IGLESIA PENTECOSTAL
EMANUEL, INC.

6300 MOONGLOW DR
SP-2020-0324C

VARIANCE REQUEST

Vary from LDC 25-8-261 to allow construction of a drive in a CWQZ to provide site access.

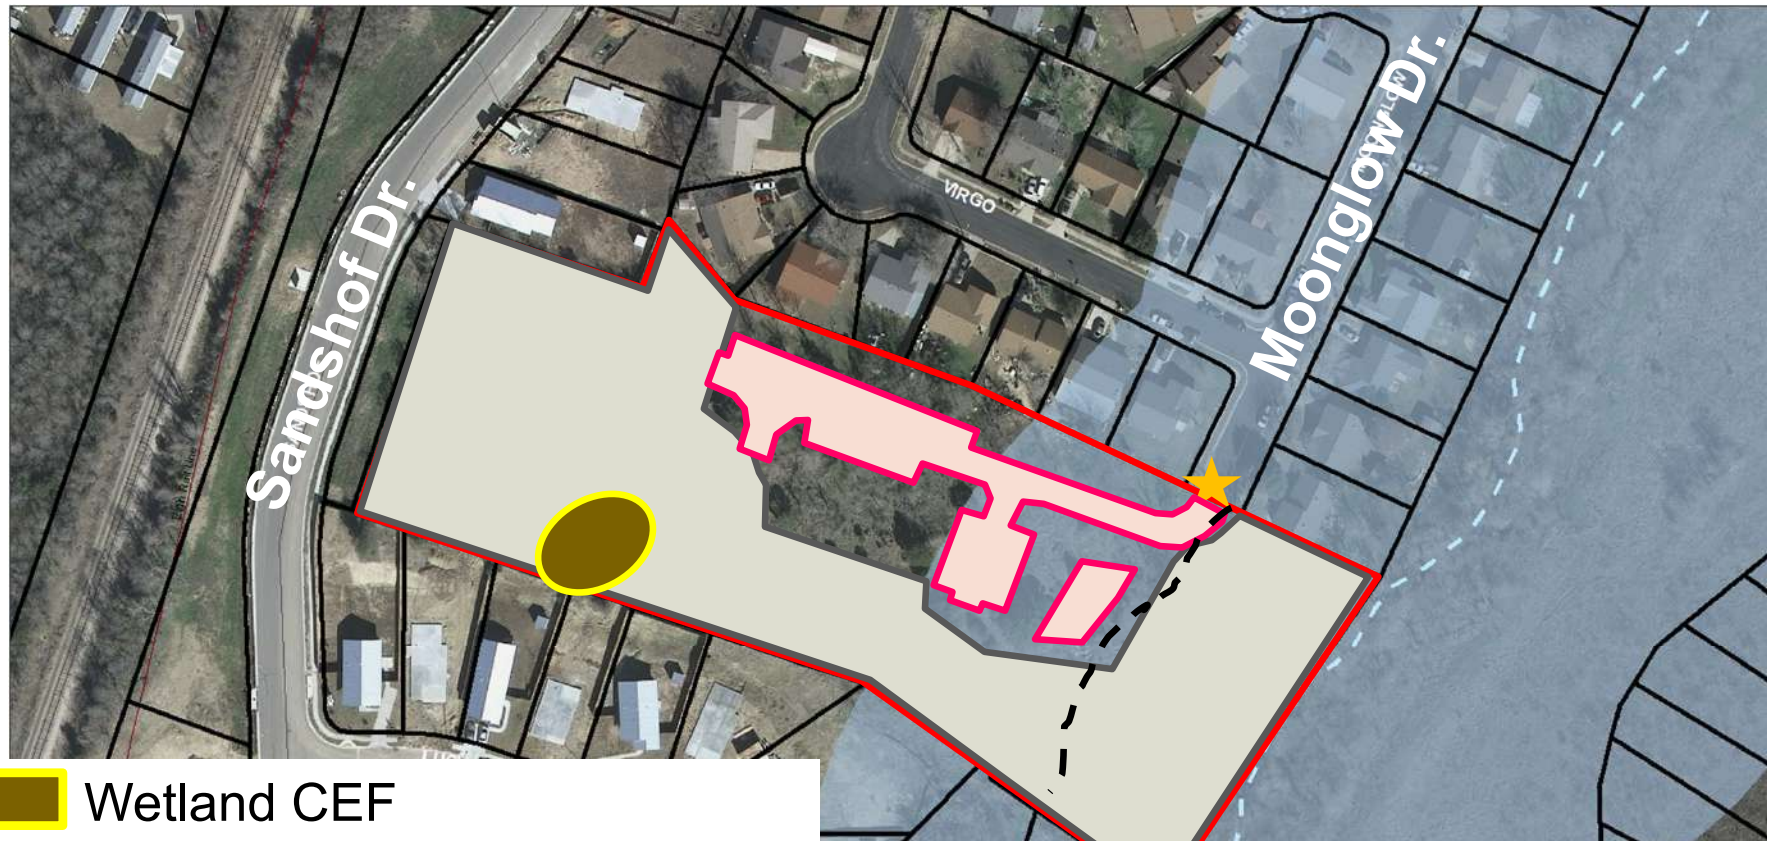
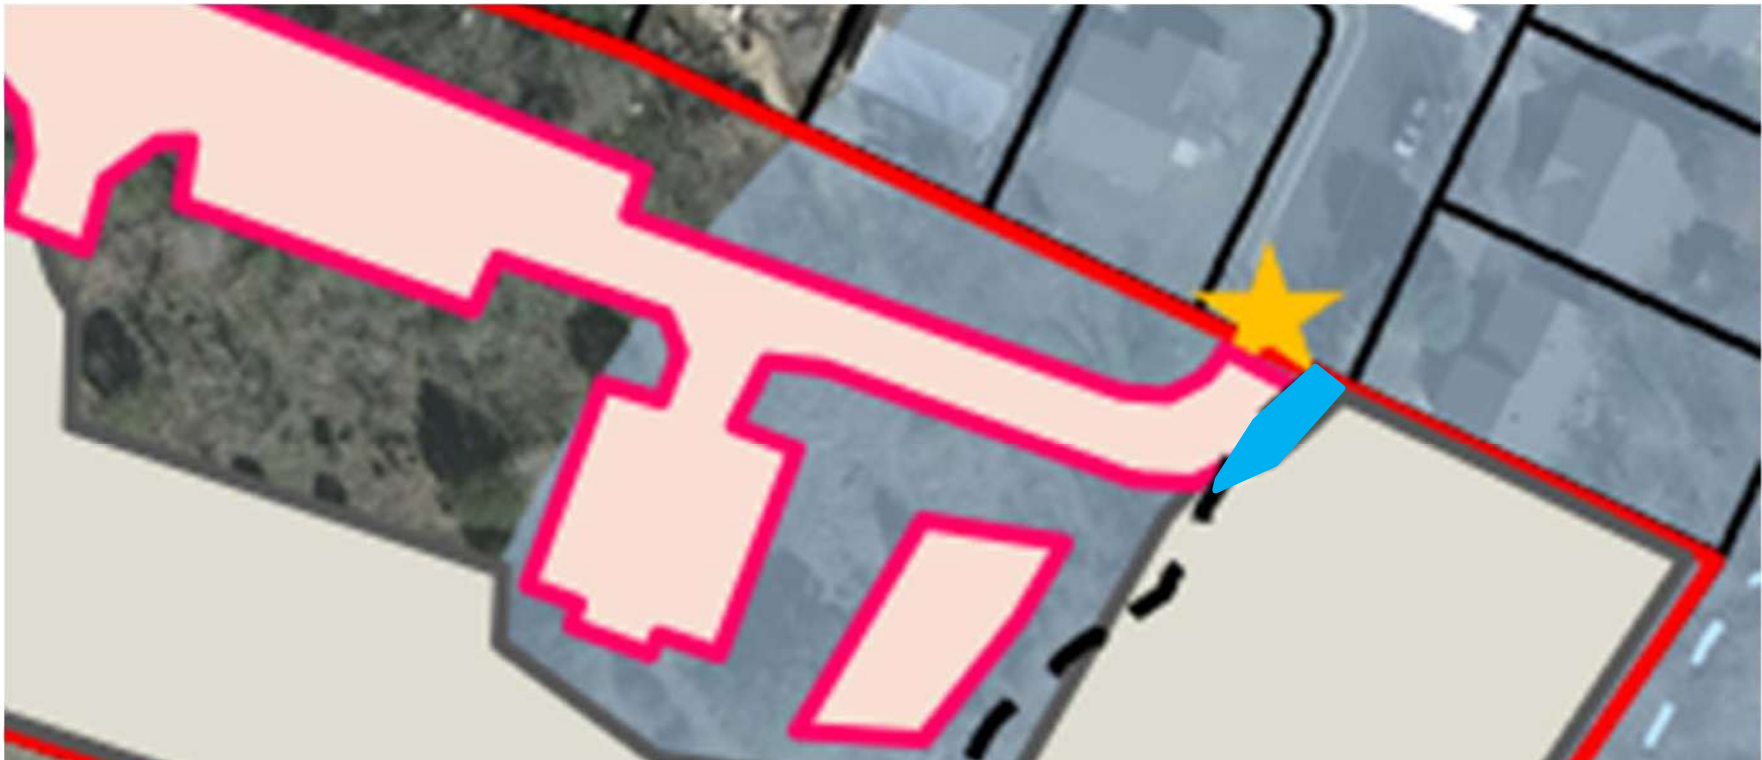
|  Wetland CEF |  478' of driveway in the CWQZ |

VARIANCE RECOMMENDATION

Vary from LDC 25-8-261 to allow construction of a drive in a CWQZ to provide site access.

STAFF RECOMMENDATION:

This proposal meets the findings of fact. Staff recommends approval, with the following condition:

The applicant will provide bollards at appropriate locations adjacent to the driveway and parking area to prevent vehicle parking off of the pavement.
